Proposed Revisions to a Standard Plans Index

Originator:	Turley, Joshua	Index Number:	455-114
Date:	8/21/2024	Sheet Number(s):	2
E-mail:	Joshua.Turley@dot.state.fl.us	Index Title:	14" SQUARE CFRP & SS PRESTRESSED CONCRETE PILE

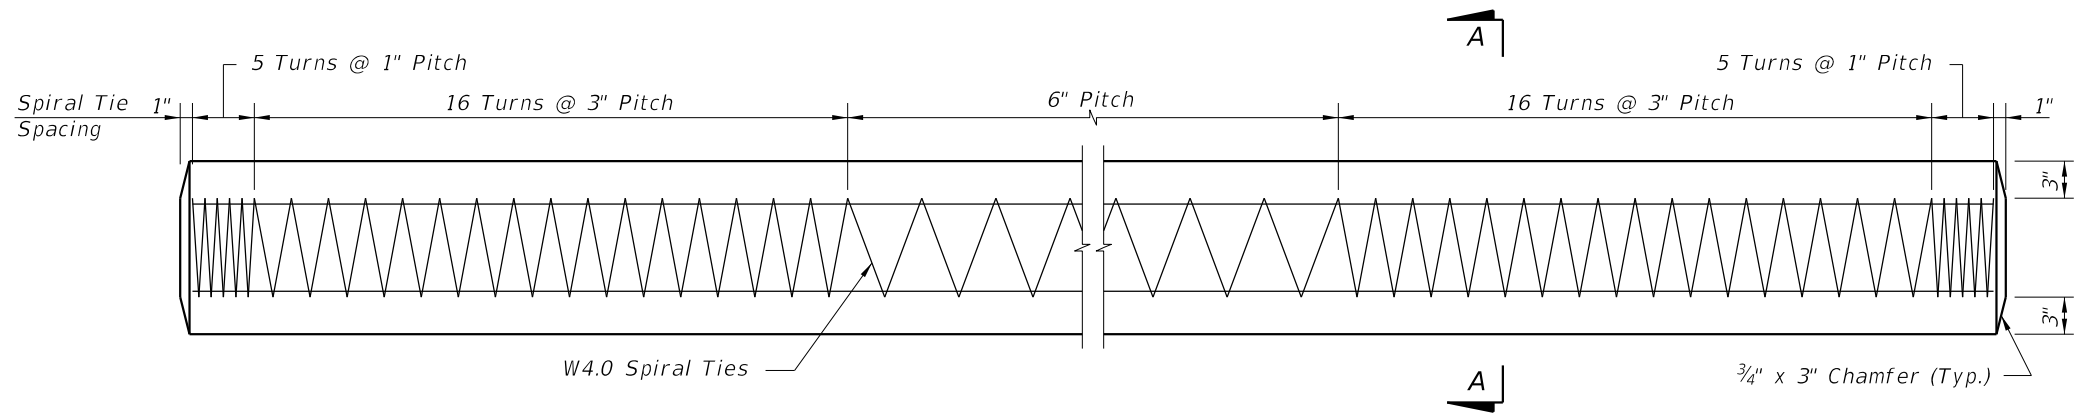
Sheet 2: Adjusted Strand Pattern diameter decimal places

This is a more accurate representation of the nominal diameter driven by the fact that the strands are fabricated in millimeters not inches.
